Missoula County  
South Avenue Bridge Project

Subject:	Project TDC Meeting No. 01	Meeting Location:	HDR Engineering Inc. Office 700 SW Higgins Street, Suite 200 (Rock Creek Conference Room)
Meeting Date:	May 10, 2016; 12:00 PM (Mountain)	Conference Call Information:	Call-in: n/a Code: n/a
Notes by:	Chris Kelly	Minutes Issued:	May 13, 2016

**PROJECT: SOUTH AVENUE BRIDGE  
PRELIMINARY FLOODWAY ALIGNMENT**

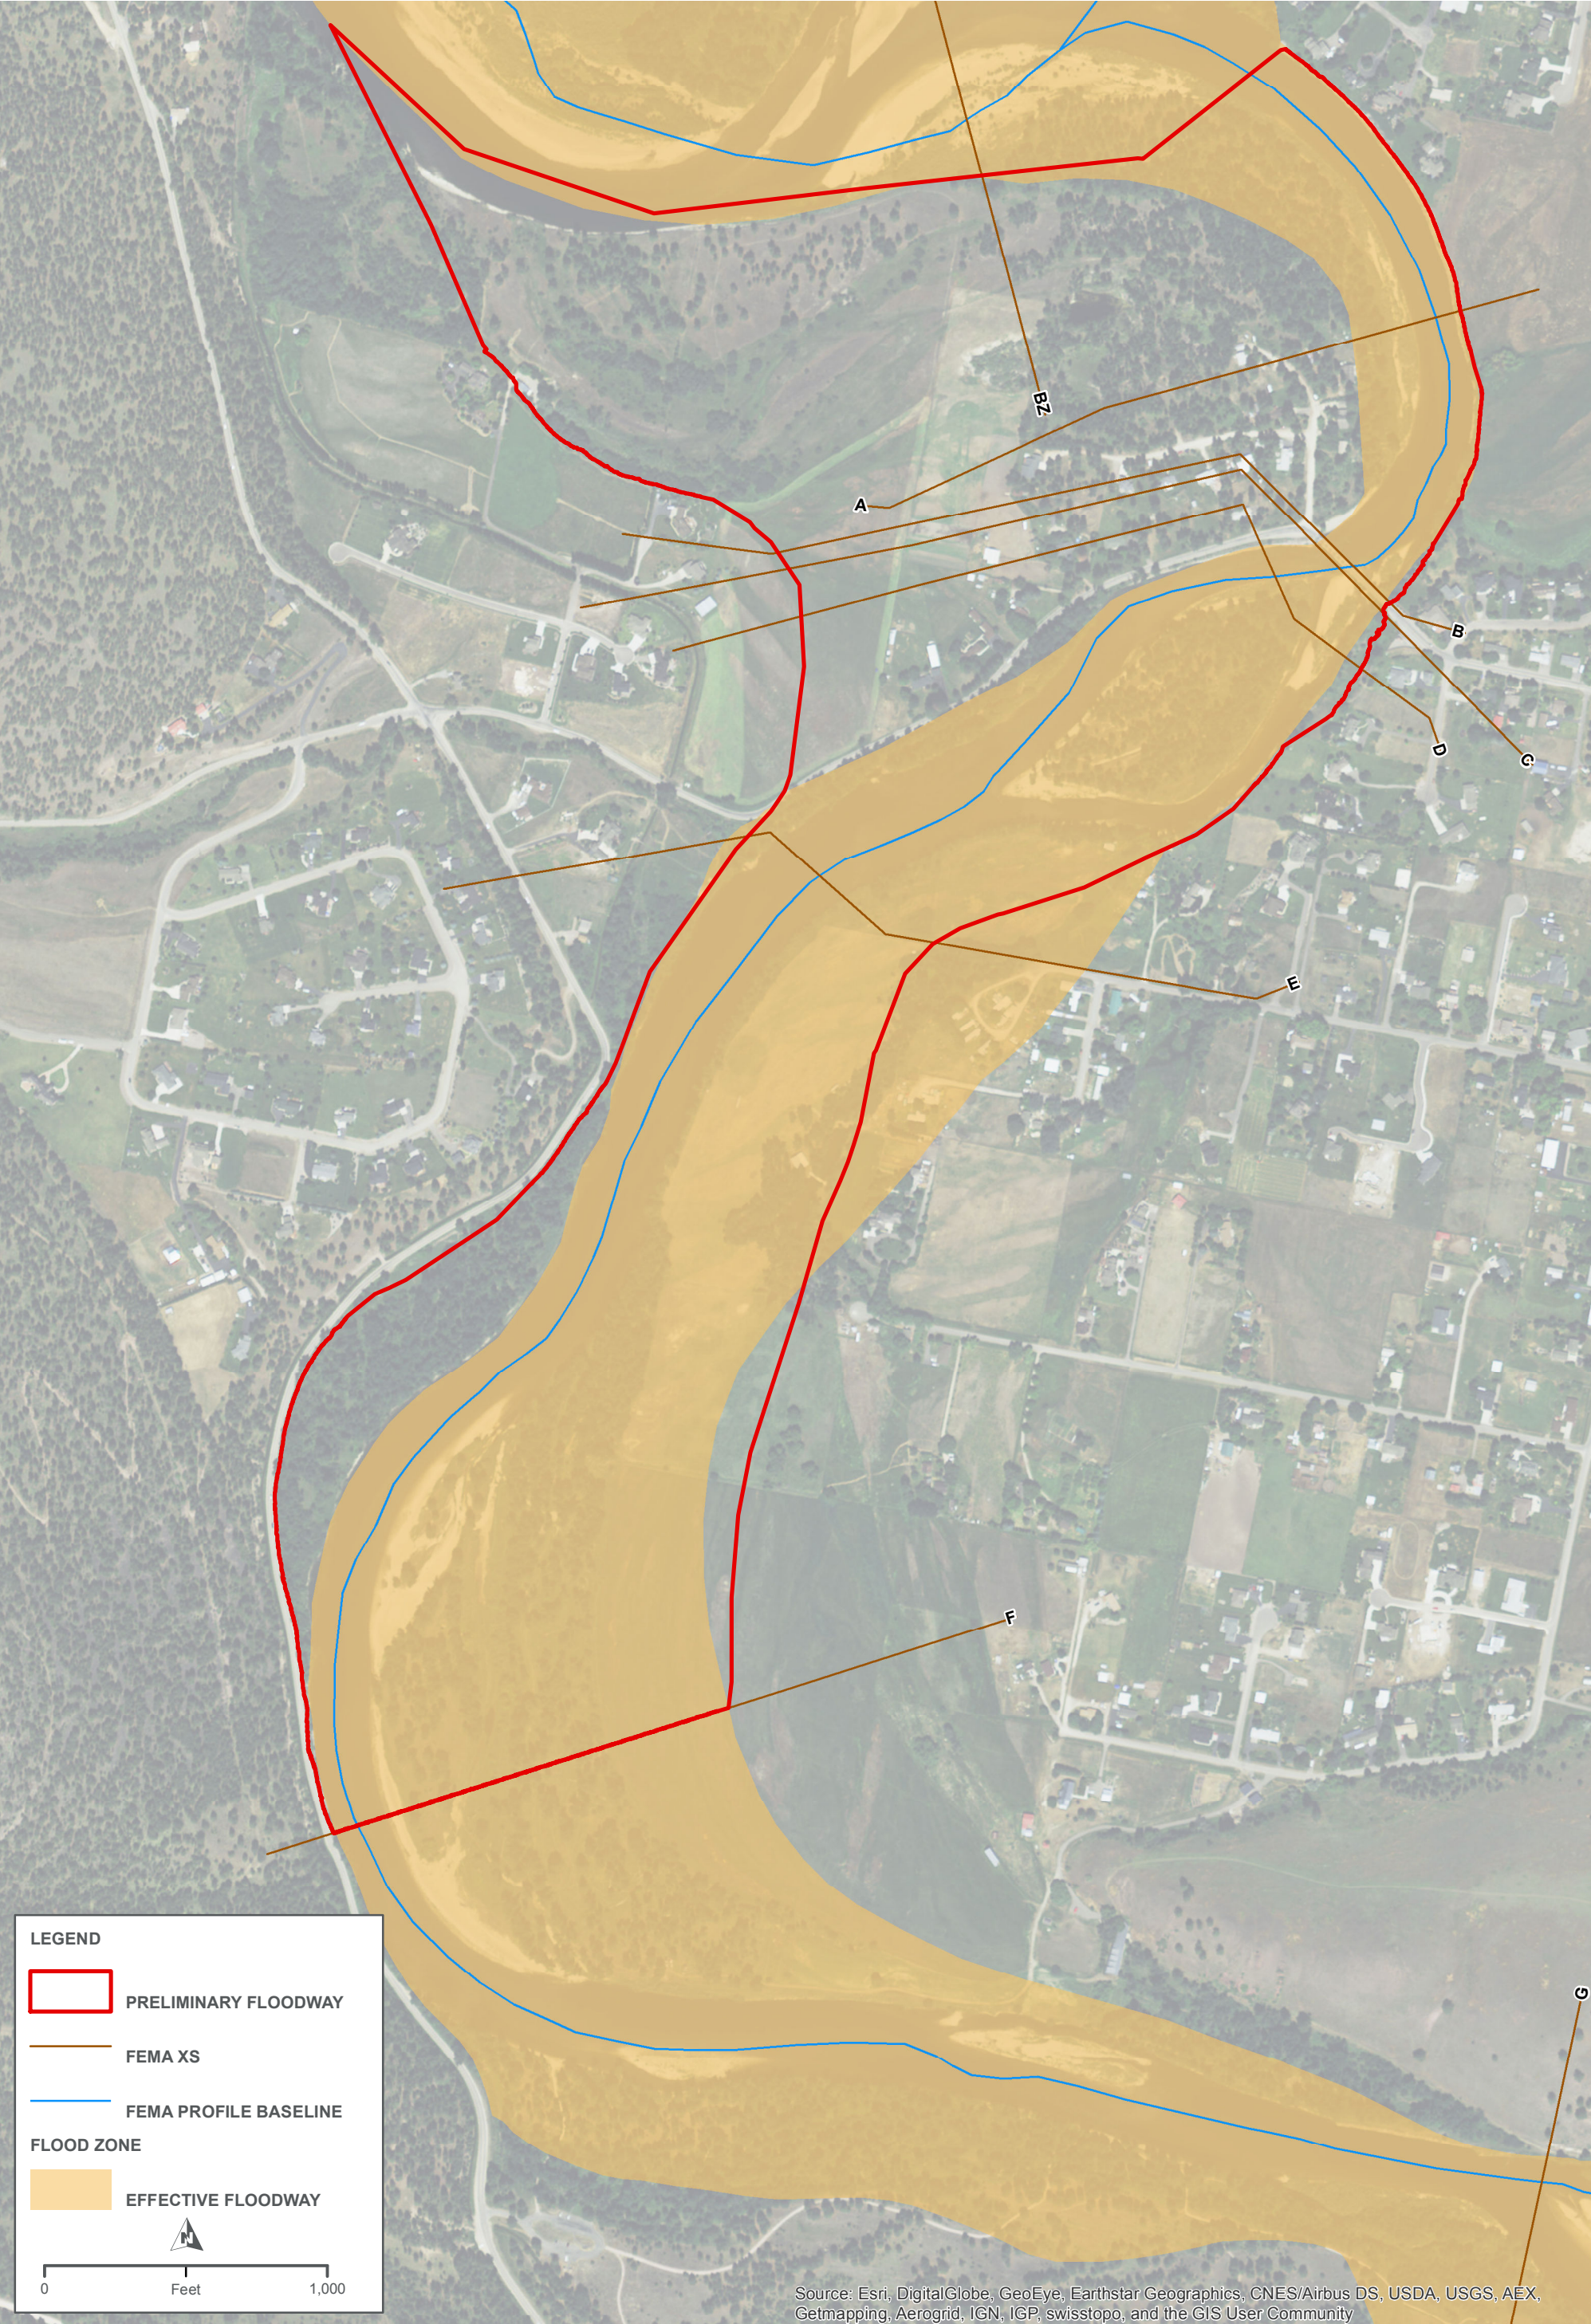
- Shaded Area: West bank follows River Pines Road. If this is used as the boundary, between D and E we would have a rise of over 2 feet in the floodway, rather than the floodplain.

- Preliminary Floodway (Red Line): Preliminary floodway, where things SHOULD be. Gets really wide at E. Upstream, between E and F, can be narrower than it is now (spacing of cross sections for effective model).

- Brown Line (FEMA cross section locations): Between E and F are a very long space (4,000 feet); issue is between D and E.
- River Pines Road is a manmade levee.

- Q: (Mike Burnside) The shaded area is FEMA's mapping and it should be between the red lines?
- A: Correct. It's accurate at cross sections, but with more cross sections added in, it's incorrect, it was a little too coarse.

- A: Correct. You have to treat it like it's not a levee.
- Q: (Dave Loomis) The Dark Red Line – this is the existing conditions? And after the bridge is constructed the red line will change again?

- A: Correct. After the bridge is constructed, the change will be minor.
- Q: (Mike Burnside) What is the impact of removing Maclay Bridge?
- A: Found that the river is steep enough that Maclay Bridge removal impacts don't reach that far upstream.
